Access Compliance Report

Public Rights-of-Way

Intersection ID: 49275	Main Street: GATHERING_CT	Cross Street: REUNION_ST	Location: NE
ADA ID: FD9D74895ED0	Ramp Type: PerpDiag	Initial Pass/Fail: Fail	Overall Compliance: No
Severity Score: 10			
Codes/Mitigation Info/Possible Solution		Field Measurements/Component Compliance

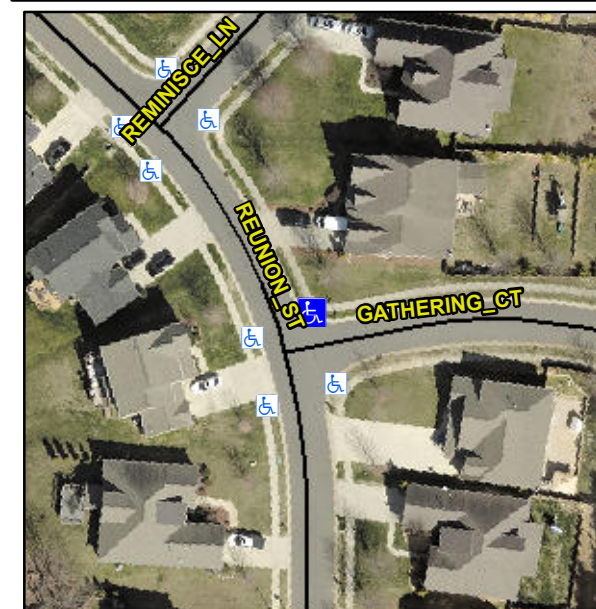
Not Found, R304.5.1, R304.5.3

Compliance	Description	Data	Compliance	Description	Data
N/A	Ramp Length (in)	47.0	Yes	Ramp Slope (%)	5.2
No	Ramp Width (in)	47.0	No	Ramp XSlope (%)	4.4
N/A	Flare Type LT	N/A	N/A	Flare Type RT	N/A
N/A	Flare Slope LT (%)	N/A	N/A	Flare Slope RT (%)	N/A
N/A	Flare Traversable LT?	N/A	N/A	Flare Traversable RT?	N/A
N/A	Landing Length (in)	N/A	N/A	DWS Provided?	N/A
N/A	Landing Width (in)	N/A	N/A	DWS Contrast?	N/A
N/A	Landing Slope (%)	N/A	N/A	DWS Length (in)	N/A
N/A	Landing X Slope (%)	N/A	N/A	DWS Full Width?	N/A
N/A	Landing Curb? (Y/N)	N/A	N/A	DWS Offset (in)	N/A
N/A	Shared Landing?	N/A			
N/A	Gutter Ponding?	N/A	N/A	Gutter Slope (%)	N/A
N/A	Gutter Lip Ht (in)	N/A	N/A	Gutter X Slope (%)	N/A
N/A	Painted X Walk1?	No	N/A	Painted X Walk2?	No
	X Walk 1 Direction	To W		X Walk 2 Direction	To S
N/A	X Walk 1 Width (in)	N/A	N/A	X Walk 2 Width (in)	N/A
	X Walk 1 Slope (%)	2.1		X Walk 2 Slope (%)	3.9
	X Walk 1 X Slope (%)	4.5		X Walk 2 X Slope (%)	2.3

Remove & Replace Curb Ramp With Two New Directional Ramps or Equivalent.
